STAKEHOLDER MEETING MINUTES
KIMLEY HORN PROJECT LIST
 5:30 PM on Tuesday, November 14, 2023
 Tom Petty Park Pickleball Improvements

A Stakeholder meeting was held on November 14th, 2023, by the City of Gainesville Wild Spaces & Public Places (WSPP) team and the Kimley-Horn Design Team to gain input from the community on the ‘Preliminary Schematic Plan’ showing proposed improvements at Tom Petty Park. Supporting material also included at the meeting was a contextual ‘Project Area’ map and an ‘Image Board’ with example images of proposed improvements. See attachments for the boards as presented. Below includes the input received at the meeting.

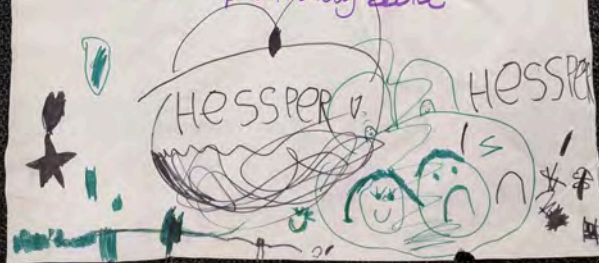
multi-use pad (120' x 60')

↳ currently use ex. pad

Shade w/in dog areas

Bike
↳ Multipurpose court for martial arts, dance, etc. bike

Fewer Pickleball and preserve more trees - Specifically South

→ Shade Sails over the playground equipment
→ a Community Kiosk on the Southside

→ New Benches in Dog Park (more benches) LARGE
↳ locate w/ user input

→ Basketball court

→ Covered pavilion in dog park w/ picnic TABLES

→ Prohibition of R/W & Sidewalk blocking by CARS

- Concern with tree demolition/removal

- Concession Bldg / window ^{↳ esp for covered pickleball courts}

- Dog park dirt ^{marking} ~~building~~ up at corners due to dog ^{marking}
~~corners~~ and no grass, exposing bench footings, bolts, etc.

- Is there opportunity for a stage/
Small stage ^{or} (related to "Tom Petty" name sake)

Area to the south floods
to tennis
courts
sometimes

→ Scale down pickleball courts to 6, remove covered courts
(trees and noise concerns)
removal
